February 18, 2008

**SUBJECT: Comments on Tentative Order – Waste Discharge Requirements for the City of Modesto Water Quality Control Facility – Stanislaus County - NPDES permit No. CA0079103**

## ATTACHMENT A. DETAILED COMMENTS ON TENTATIVE ORDER

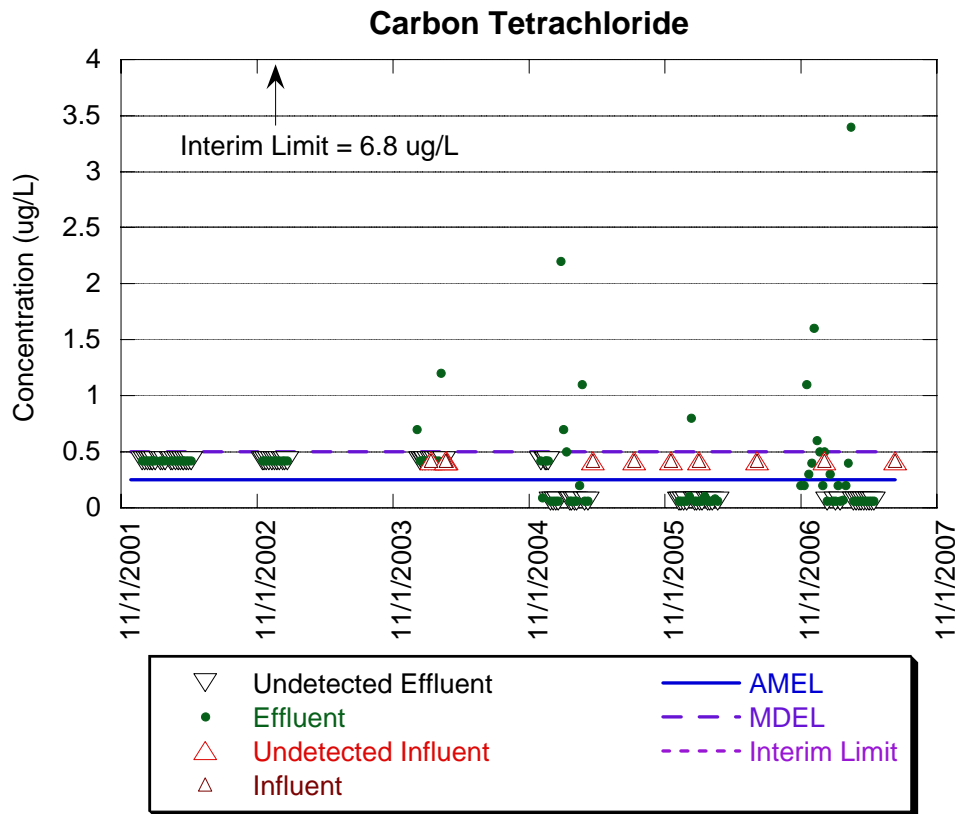
The figure below comparing influent and effluent concentrations of carbon tetrachloride (CCl<sub>4</sub>) at the WQCF indicates that there are detected levels of CCl<sub>4</sub> in the effluent, but no detected levels of CCl<sub>4</sub> in the influent. These data suggest that there are no influent sources of CCl<sub>4</sub> that discharge to the WQCF and that the source of CCl<sub>4</sub> in the effluent is the chlorination process within the WWTP. The scientific

literature indicates that  $\text{CCl}_4$  can be formed as chlorine disinfection byproduct<sup>7</sup>. Another potential source of  $\text{CCl}_4$  in the WQCF is contamination from  $\text{CCl}_4$  used in the chlorine cylinder cleaning process<sup>8</sup>.

Considering that  $\text{CCl}_4$  is well recognized as a chlorination byproduct and that the WQCF has no apparent influent sources of  $\text{CCl}_4$ , it is reasonable to conclude that use of UV disinfection in place of chlorine disinfection for tertiary effluent should eliminate the formation of  $\text{CCl}_4$  within the tertiary treatment element of the WQCF. Thus,  $\text{CCl}_4$  should be considered in the same manner as THMs with respect to WQBELs. Consequently, the City requests that WQBELs for  $\text{CCl}_4$  be removed for tertiary effluent.
